TOSHIBA Microcontrollers TLCS-870 Family
TLCS-870/C1 Series

Restrictions on the Voltage Detection Circuit

Datasheet Corrections: Electrical Characteristics of the Power-On Reset Circuit

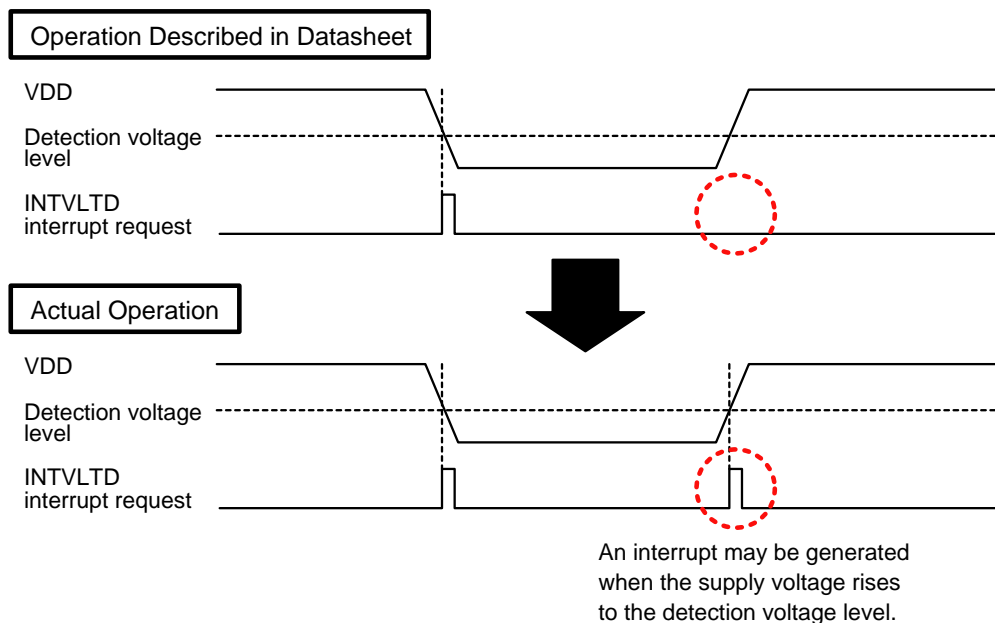
1. INTVLTD Interrupt Request

When interrupt generation is enabled in the voltage detection circuit, an INTVLTD interrupt request may be generated not only when the supply voltage falls to the detection voltage level, but also when it rises to the detection voltage level.

In ICE mode of the In-Circuit Emulator (TMP89C900), no interrupt request is generated when the supply voltage rises to the detection voltage level. Therefore, with products supporting the In-Circuit Emulator (TMP89C900), the interrupt generation operation may differ between the development tool and the actual product.

2. Releasing STOP Mode by Voltage Detection

The SRSS bit in the voltage detection control register 2 (VDCR2) provided for releasing STOP mode by voltage detection cannot be used because it does not function as expected.

Do not use the INTVLTD interrupt for voltage detection. The voltage level should be regularly checked using other timing such as the execution cycle of the main program. VDCR1<VDxSF> (x=1, 2) can be used to check the voltage level. However, if the operating voltage is near the detection voltage, the VDCR1<VDxSF> value may become unstable. It is recommended that VDCR1<VDxSF> be tested multiple times to determine the voltage level.

Always set VDCR2<SRSS> to "00". Use the STOP pin to release STOP mode.
